HEALTHCARE INTERPRETATIONS TASK FORCE

AGENDA

JUNE 14, 2011

INTERPRETATION REQUESTS JUNE 2011

ITEM A-5 – ALCOHOL HAND RUB

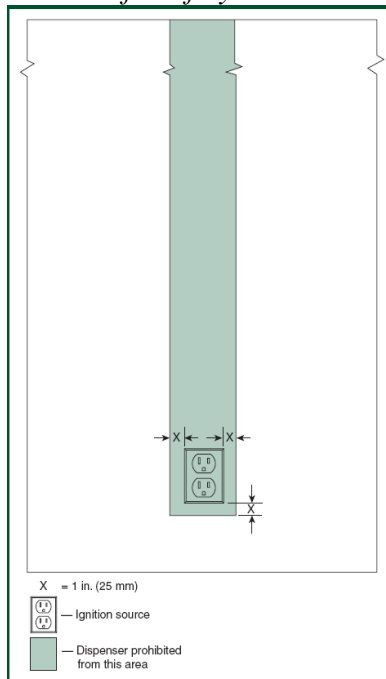
The 2000 Life Safety Code TIA and 2006 Code allowed for AHJ judgment/interpretation concerning proximity to ignition sources. Section 19.3.2.6 (6) states, “*The dispensers shall not be installed over or directly adjacent to an ignition source.*” In 2006 The Joint Commission published information defining “adjacent to” as no closer than 6 inches, center of the dispenser to either side of the ignition source. Currently, according to TJC SIG and surveyors in the field, the interpretation enforced is 6 inches from center of the dispenser to center of the ignition source.

Especially considering that some AHJs have adopted the 2009 Life Safety Code, it seems counterproductive and confusing for TJC and possibly CMS to be surveying for “adjacent” (the 6 inch interpretation) when NFPA has more recently precisely defined dispenser and ignition source criteria. The 6 inch from center interpretation can be more stringent than the 2009 Code 1-inch criterion, resulting in the need to move multiple dispensers slightly further away when they complied with 2009 Code.

Is it the intent of The Joint Commission 2000 Code interpretation to be more stringent than the 2009 Code precise criterion?

Concerning placement of Alcohol-Based Hand-Rub Dispensers, where the 2000 Life Safety Code TIA 00-1 or the 2006 Life Safety Code is applicable, are the criteria specified in 19.3.2.6 (7) of the 2009 Life Safety Code acceptable?
